Submission RE: Barangaroo Concept Plan Amendment MP06_0162 MOD 4

Barangaroo South Concept Plan Modification
and Major Development SEPP Amendment

Director	Peter Strudwick
Consultant	Yi-Juan Koh
Job Code	SA4329
Report Detail	DR MOD 4 EA_MP06_0162 – Final Submission

Figure 1 – View Impacts Generated by Block 1

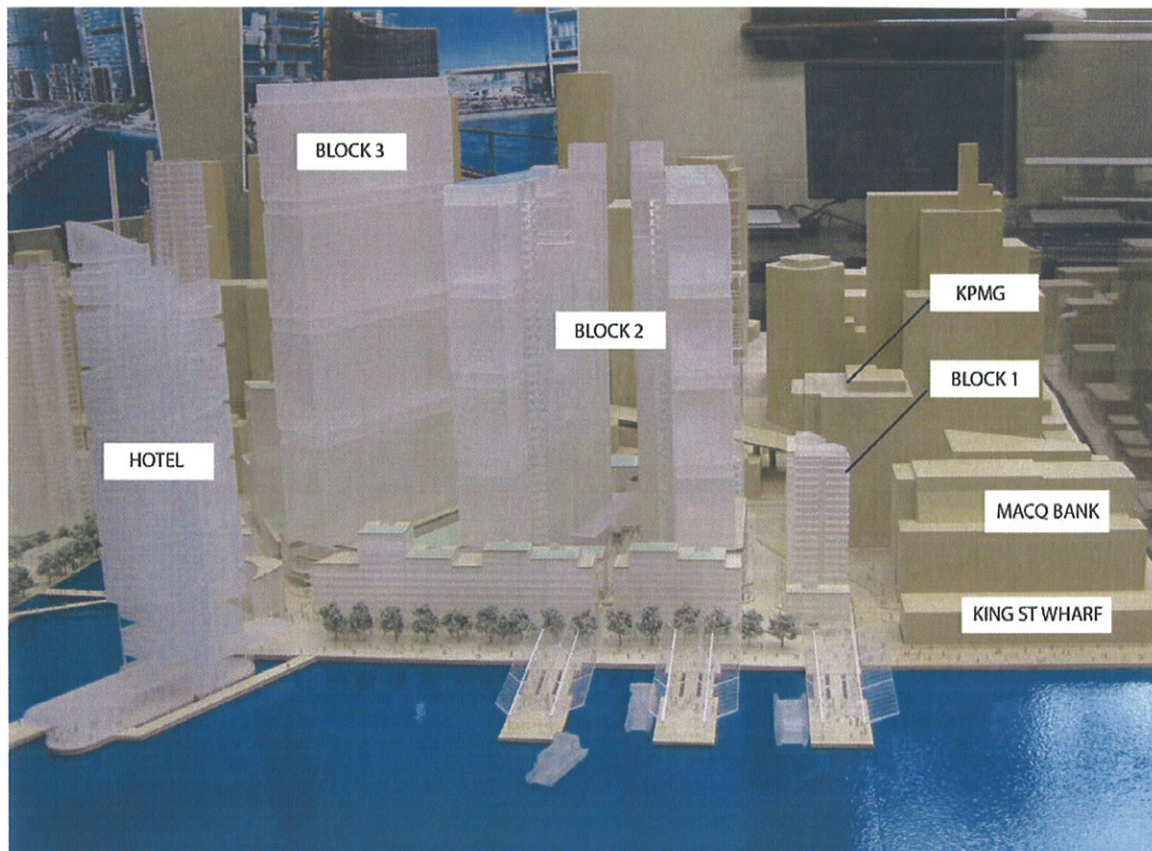
The view to be affected is recognised as a highly valuable view to Sydney Harbour. Linear views to the Harbour are currently afforded from the northern and western sides of the KPMG Tower. Under the approved Concept Plan, Block 1 impedes on linear views currently afforded from the western side of KPMG Tower (northern portion of the building). A small gap through Macquarie Bank building and Block 1 to the Harbour will remain. The proposed modifications to Block 1 as shown in Figure 1 will generate the following impacts:

- In addition to the view loss from KPMG Tower by the approved Block 1 (RL 62), the proposed additional height of 18m to Block 1 will eliminate views from 6 additional storeys of KPMG (based on 18m addition, and 3m [minimum standard] floor to floor height of residential uses).
- Block 1 impedes on the panoramic views currently afforded from the northern side of KPMG Tower. However, it is noted that retention of these panoramic views to the Harbour is unrealistic in this context.

- Block 1 impedes on the panoramic views currently afforded from Macquarie Bank building. While it is noted that retention of these panoramic views to the Harbour is unrealistic, it is reasonable to expect the protection of quality of outlook. The quality of the northern outlook from Macquarie Bank building will be reduced as a result of the amended built form principle (no. 4) that reduces minimum internal street widths from 20m to 4m. Wider street widths provide greater visual relief of the built form, and promote view protection and quality in visual outlook.

- A significant loss of linear views to the harbour from KPMG Tower; at a minimum (vertically) it will lose approximately 6 storeys of direct harbour views as a result of the Block 1 height increase. Horizontally along KPMG Tower's western side (from the north), the extent of view loss will be almost half the width of the building.
- A significant reduction in the quality of outlook from Macquarie Bank as a result of the proposed change to upper storeys from commercial to residential uses.

These impacts generated by Block 1 are considered unreasonable, given the impacts that the approved Concept Plan already impose on adjoining buildings. These impacts are primarily generated by the approved location of Block 1 in the direct view line to the Harbour from KPMG Tower.

Figure 2 – View Impacts Generated by Block 2

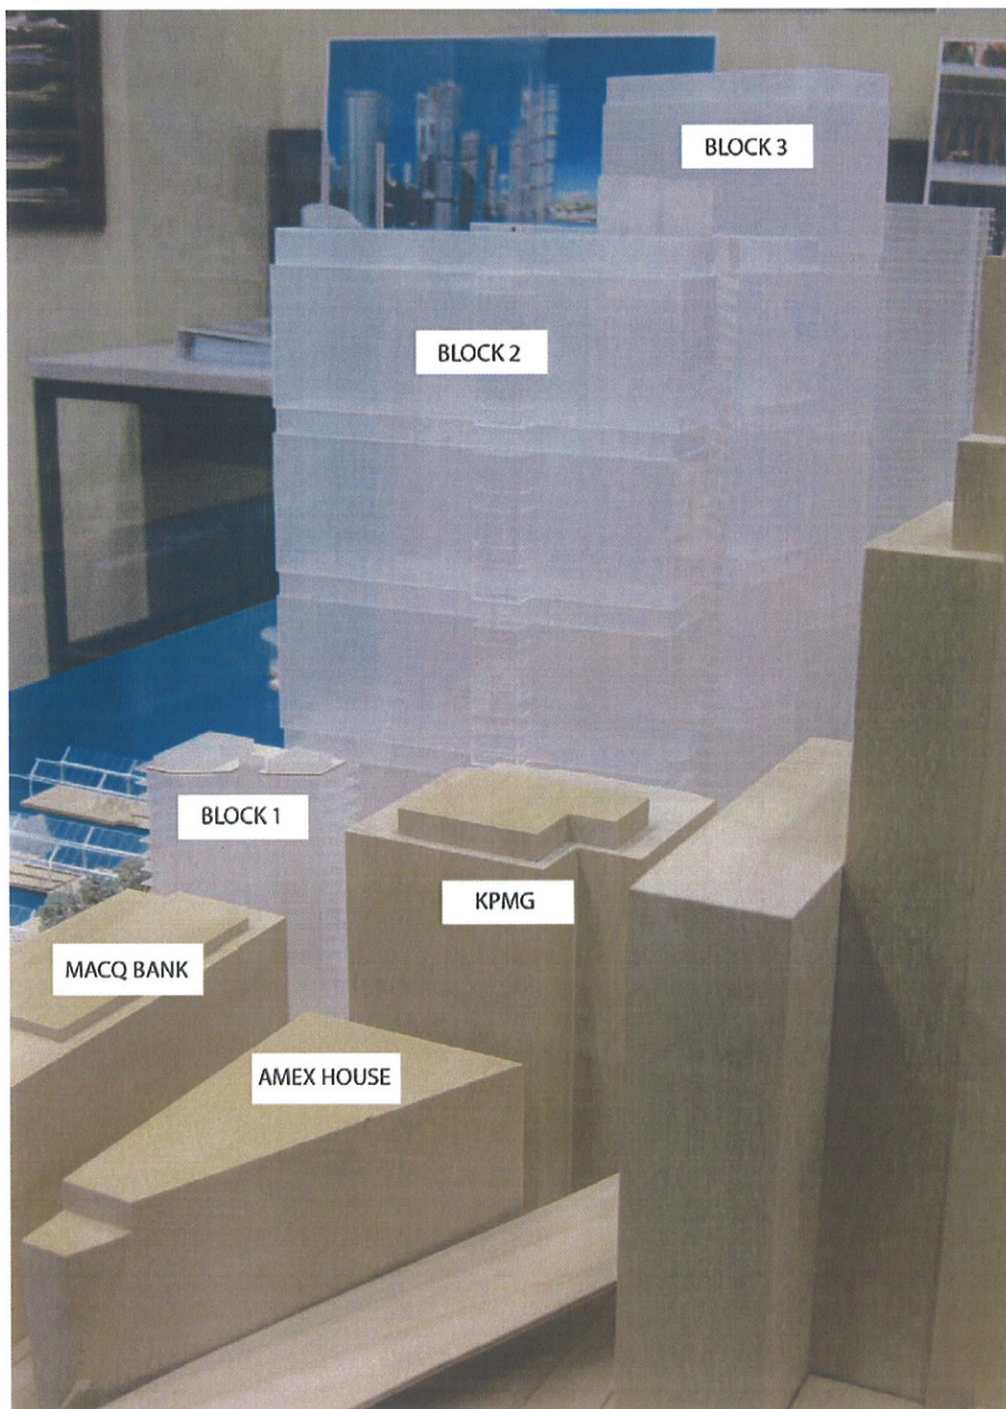
The length of Block 2 at 90m in length (east-west) poses a significant departure from the shorter building footprints of the approved Concept Plan, uninterrupted blocks of these lengths are unprecedented in the Sydney CBD. As a result of this modification, the following visual impacts as shown in Figure 2 are generated:

- Block 2 impedes on the panoramic views currently afforded from the northern side of KPMG Tower. While it is noted that retention of panoramic views to the Harbour is unrealistic, it is reasonable to expect the protection of quality of outlook.
- The quality of outlook primarily from KPMG Tower and to a lesser extent, Macquarie Bank building, will be reduced as a result of the significant, uninterrupted length of Block 2 and the removal of the north/south 'valley' in the previous design principles.

- The 90m length of Block 2 will impose upon the northern outlook of KPMG Tower and Macquarie Bank building a considerable bulk and mass, with no visual or physical relief or interest in the built form.
- Combined with the length of Block 2, the proposed height of RL 180 (unchanged from Concept Plan approval) will result in a poor visual outlook from the affected southern buildings.
- The significant and unjustified increase to the length of Block 2 (from approximately 55m based on the MOD 2 Concept Plan to 90m as currently proposed) to an unchanged building height of RL 180 in no way respects or responds to the immediate building context of the southern adjoining buildings forming the King Street Wharf Precinct.

Figure 4 – Proposed Modification: Street Connections (EA Report 2010, p 63)

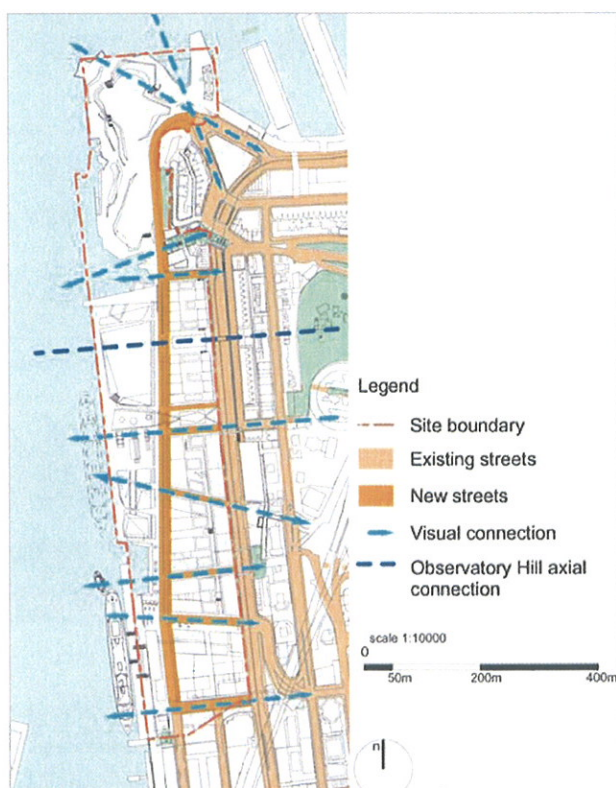
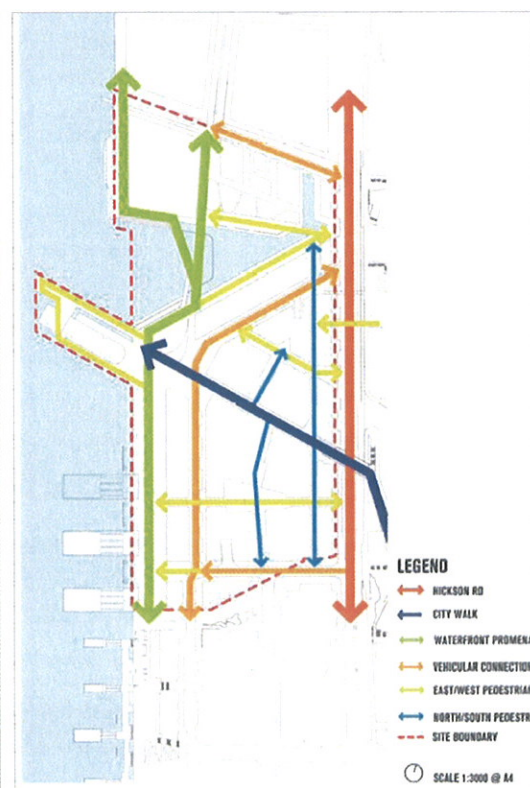
As illustrated in Figure 4, the original Concept Plan reinforced physical east-west linkages through new streets. However, Figure 4 illustrates a departure from this principle. Instead, east-west streets (Napoleon Street, Bull Street and Healy Street) linking Hickson Road with new Globe Street have been removed and replaced with pedestrian connections. The only vehicular road in Barangaroo South is now the re-aligned Globe Street that runs north-south and connects to Hickson Road (shown in orange in Figure 4).

As a result of the proposed modifications, the loss of accessibility to Barangaroo South from Hickson Road is likely to concentrate vehicular traffic onto Shelley Street, which will form the new Margaret Street West. Vehicular traffic is also likely to be funnelled through Lime Street, as the new Globe Street will be an extension of Lime Street. The result of this will reduce pedestrian amenity of Shelley Street and Lime Street.
